Bryant Planning Commission Meeting

Date: November 14, 2024 - **Time:** 6:00 PM

7. Hillcrest Addition Subdivision - 3927 Springhill Road - Preliminary Plat

Project No.	24-018
Date:	JULY 9, 2024
Scale:	1" = 20'
Drawn By:	B. Judd
Sheet:	5 of 10

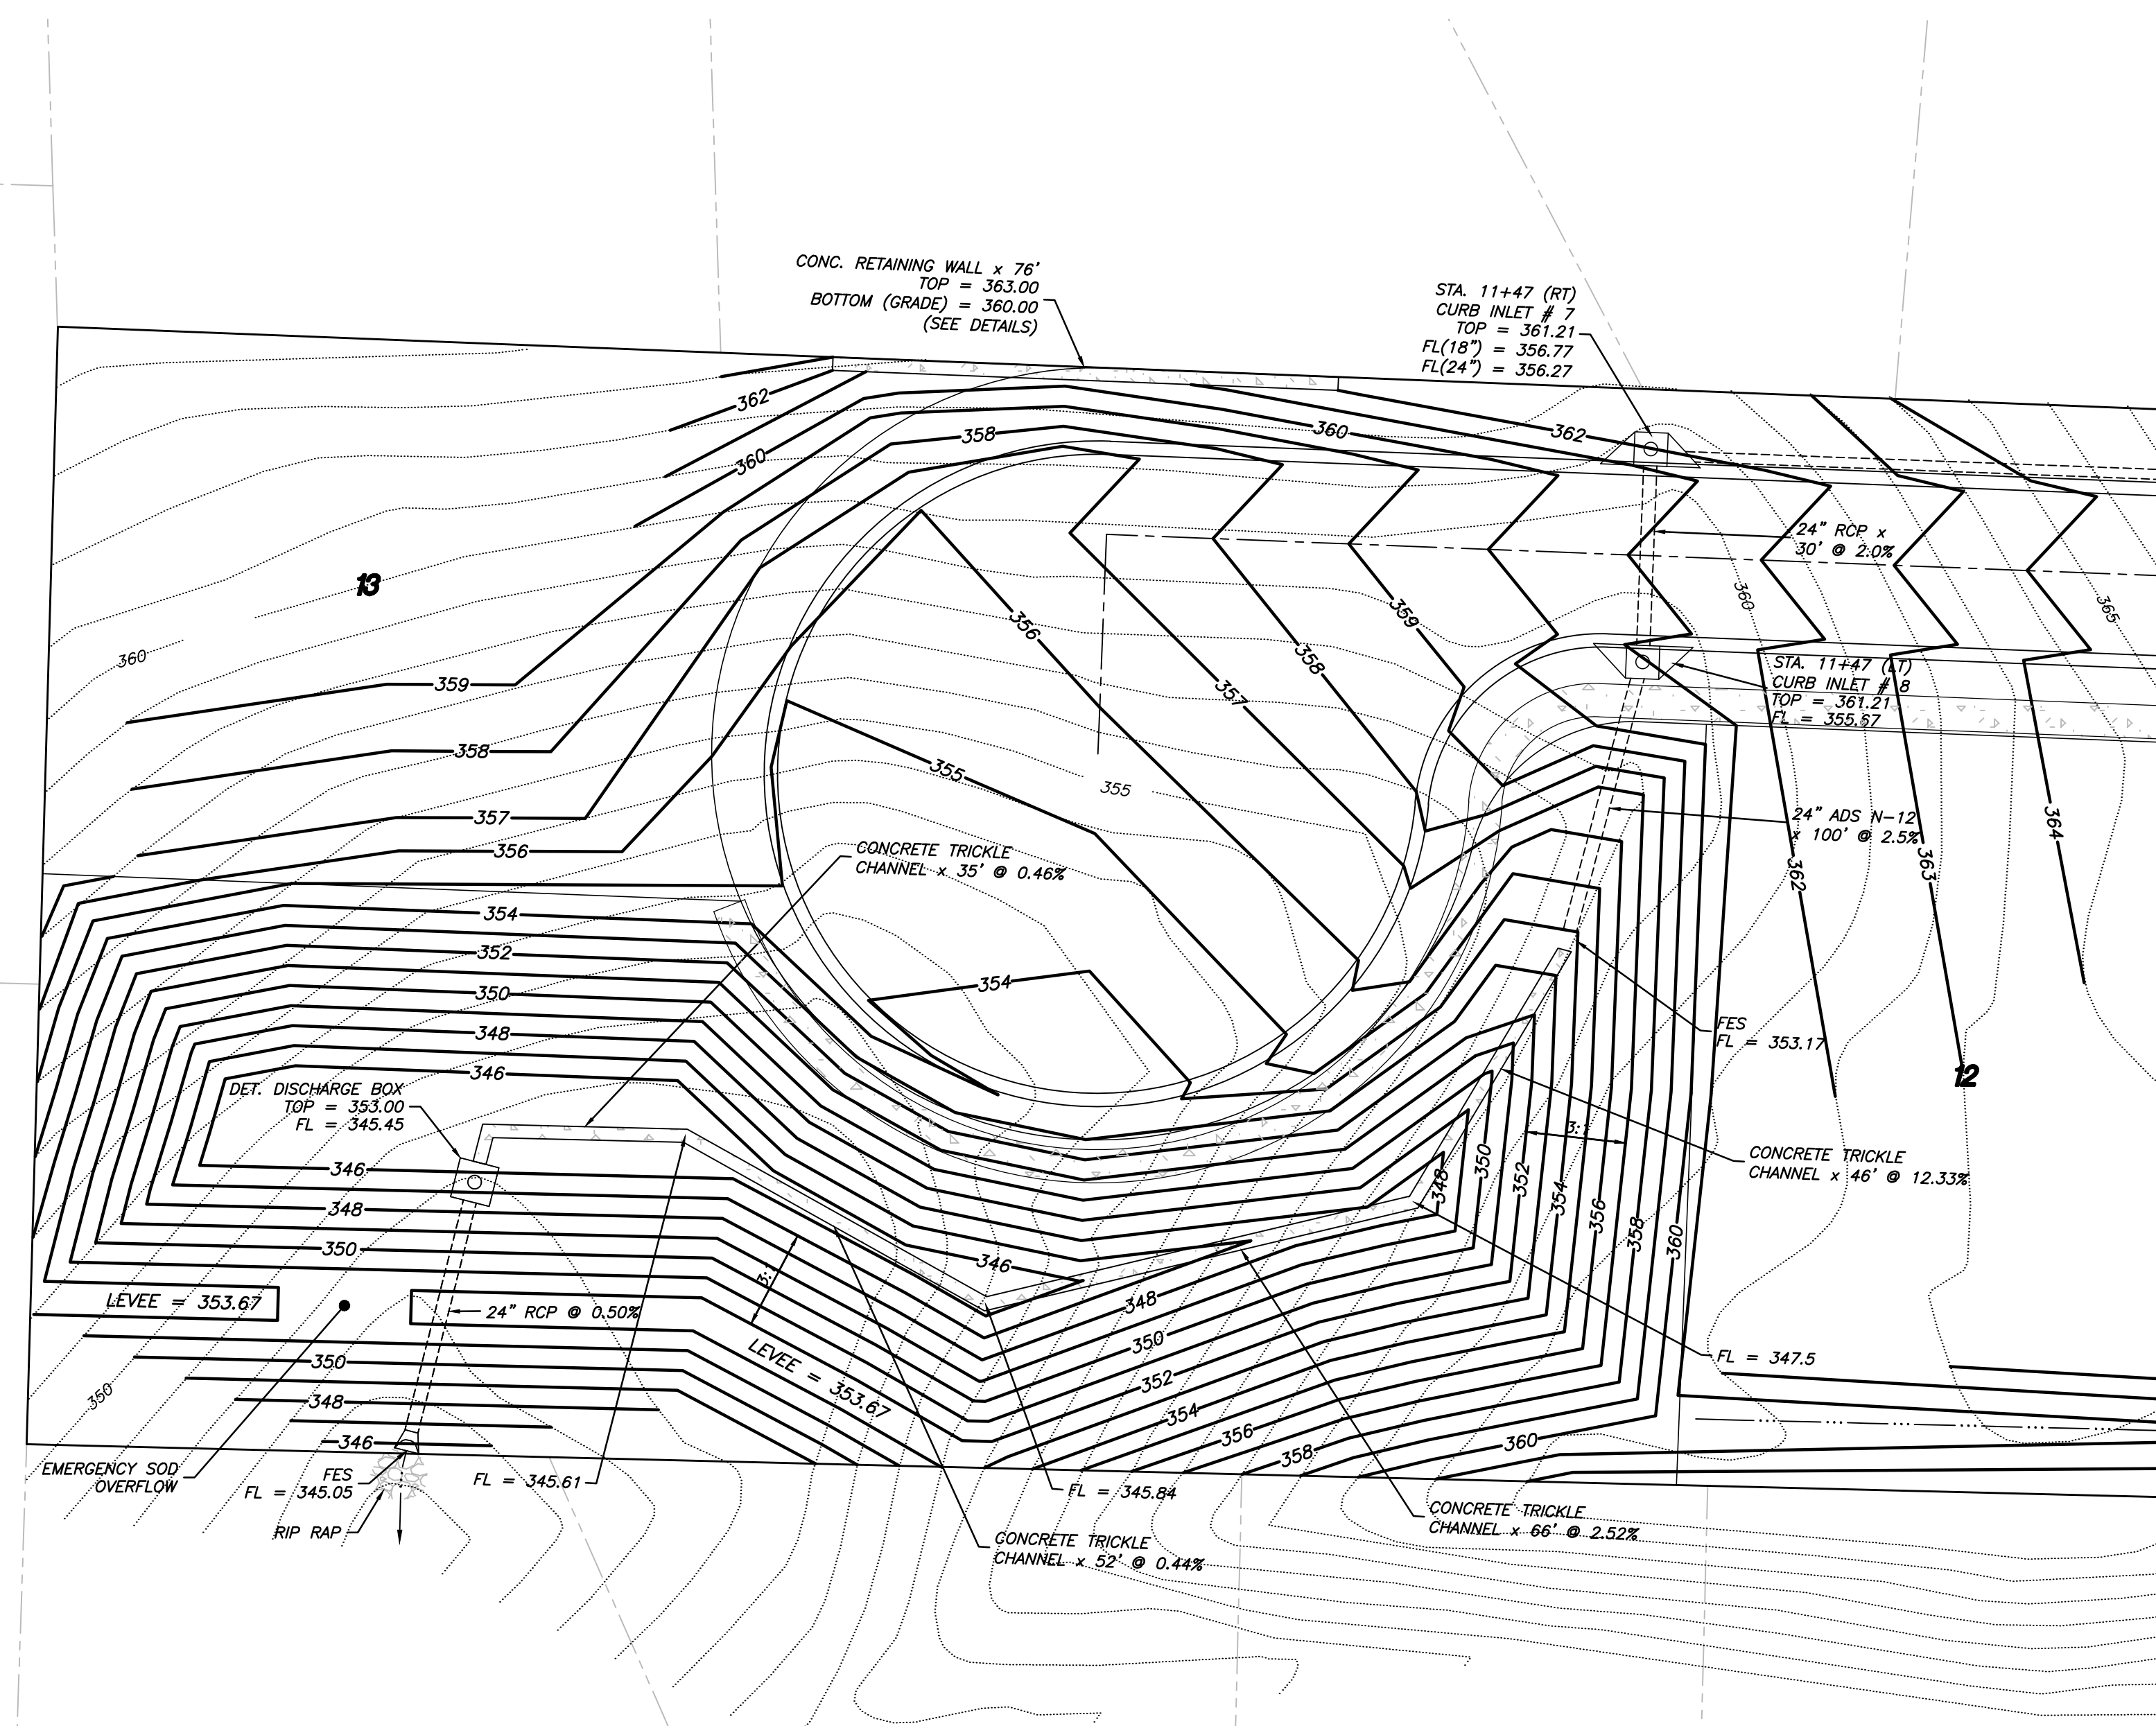
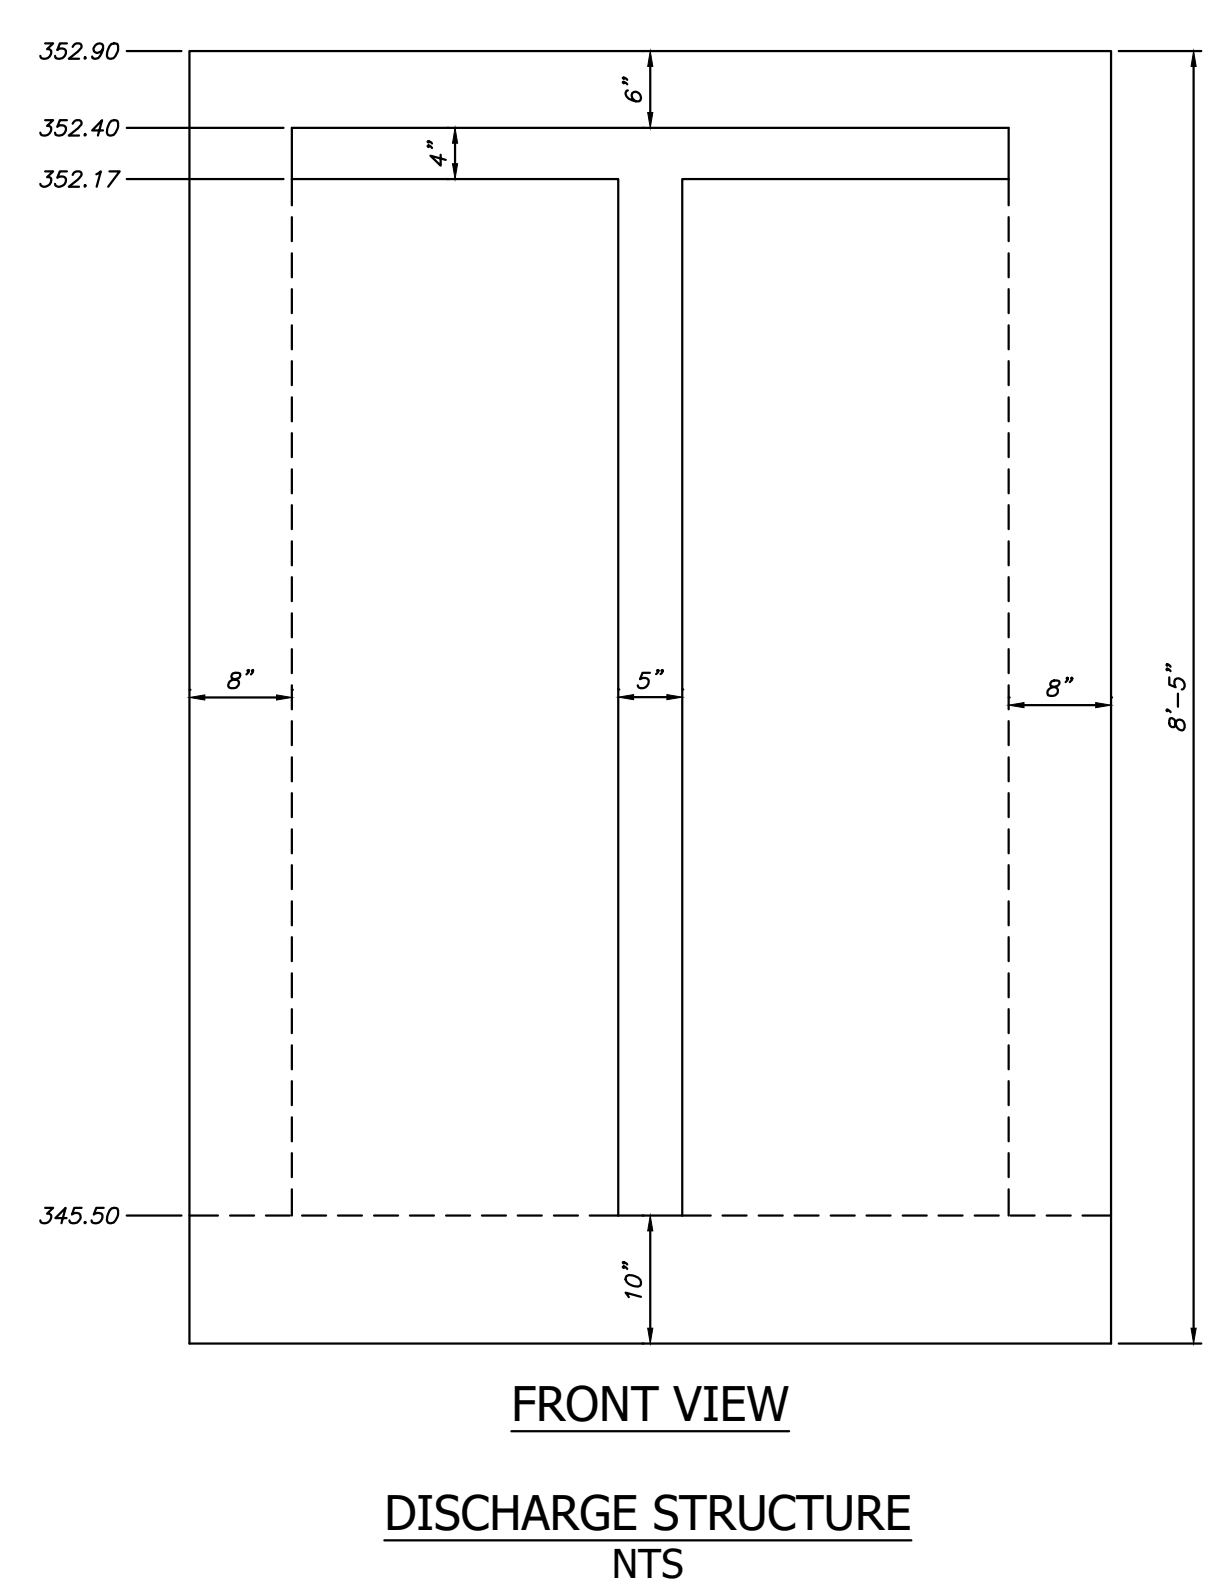
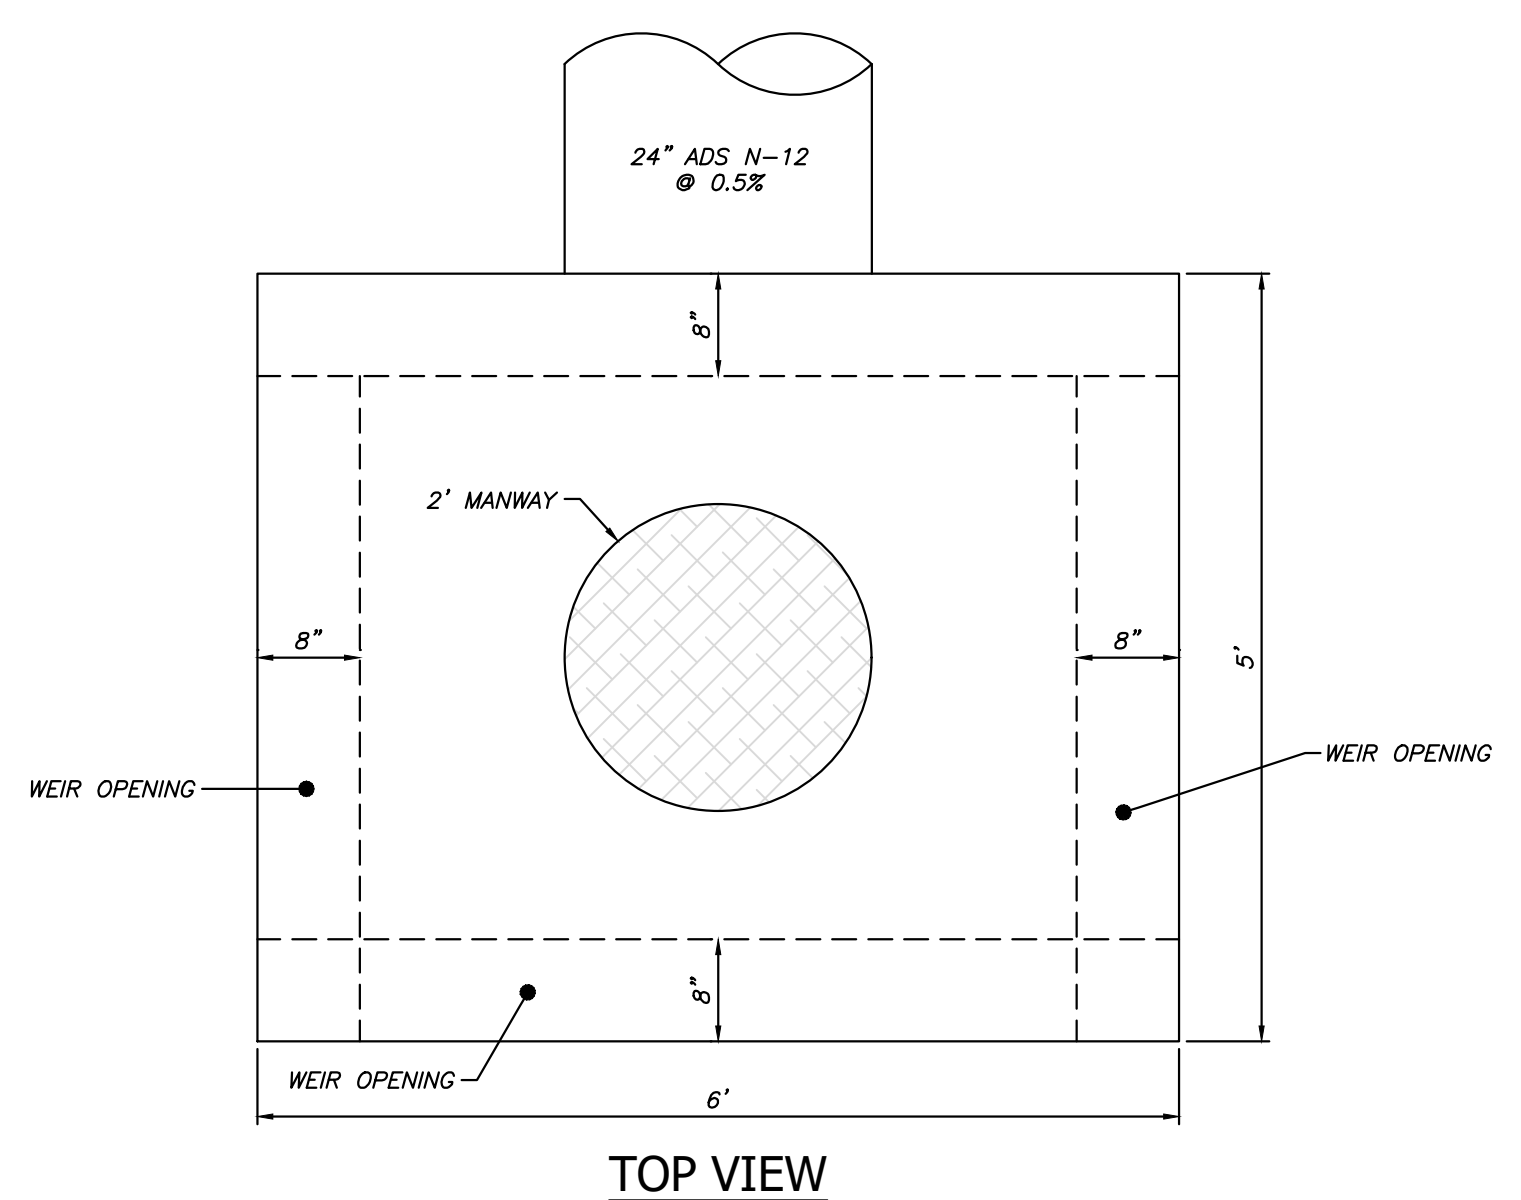
3. Sheet 5 of 10, show inlet numbers. ***Added as requested.***
4. Sheet 5 of 10, Is the top 4" slot all the way around the box beneath the top? ***Yes. I have added additional information on this detail to better represent this item.***

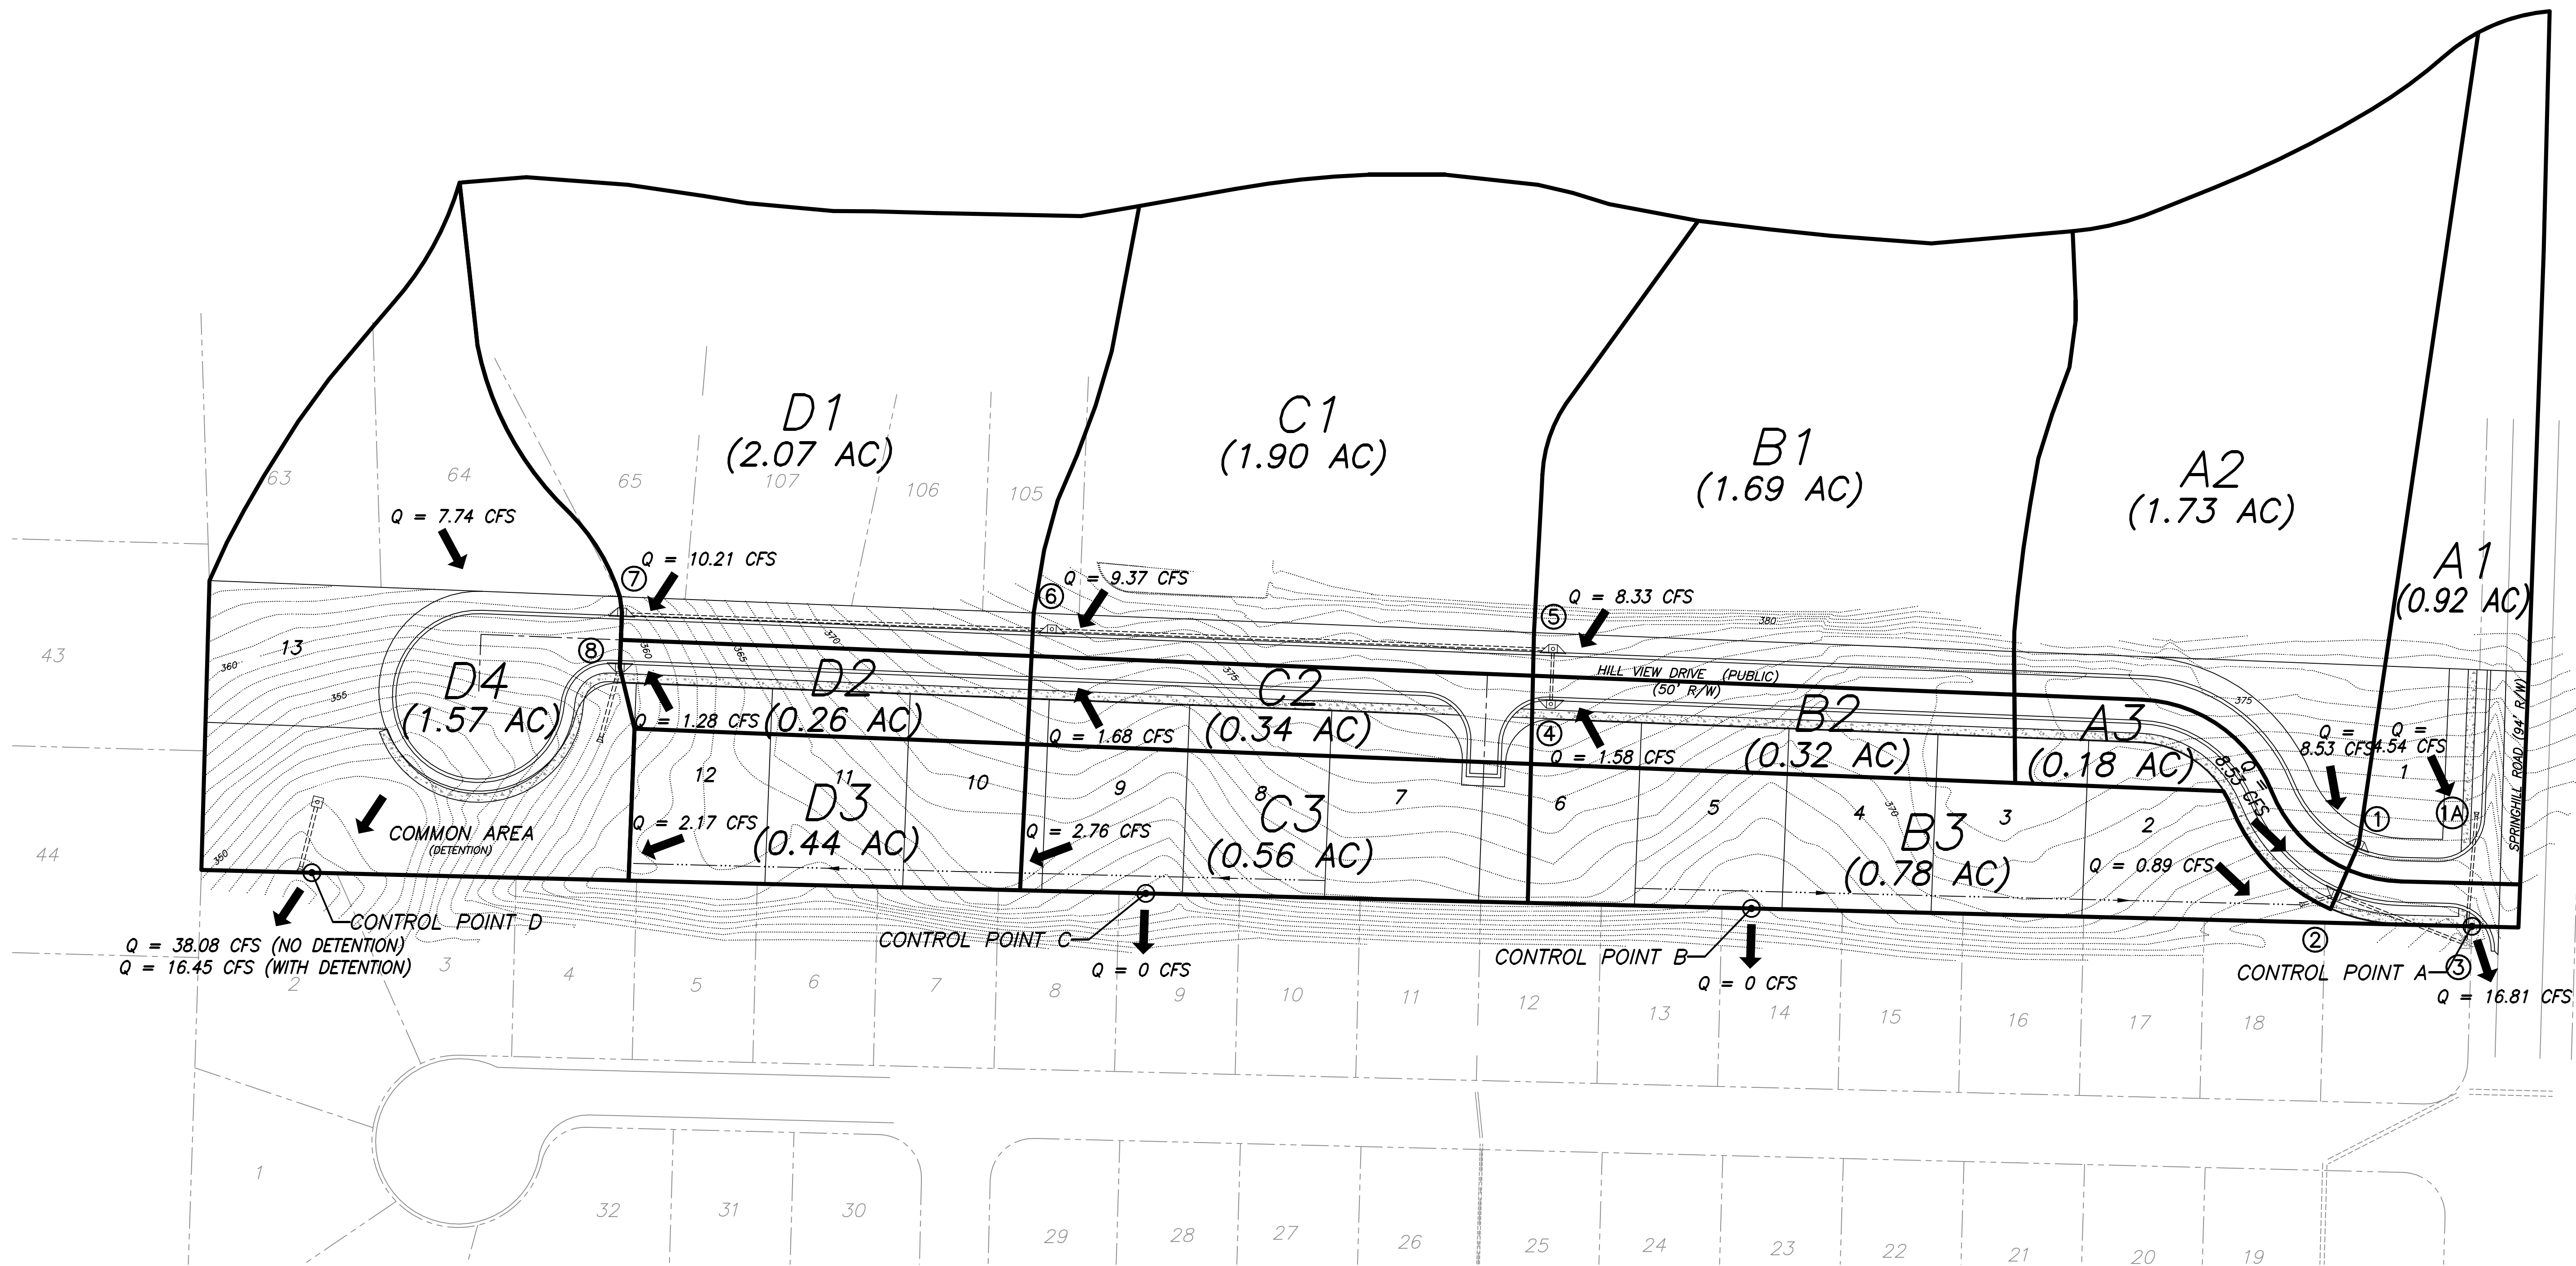
1. Sheet 3 of 10 shows the existing 18" culvert stopping just behind the curb of the half-street improvements. Since the existing ditch will be graded over, it appears that this pipe should be extended to the north and pick up flow from the north. ***We will need to consult the owners as to when the half street improvements will be constructed. If the City and the Owner agree to an in leu of cost clause, the pipe will need to end in the vicinity of where it is shown on the existing plans. We are willing to discuss this with staff.***

2. Sheet 3 of 10, show the existing ditch & culvert to the south of JB#3 along Springhill Road. Show details on how the outlet looks and how the flow will be handled to the south. ***We will be matching the existing half street road improvements from our planned intersection, to the South. This has been added to this sheet.***
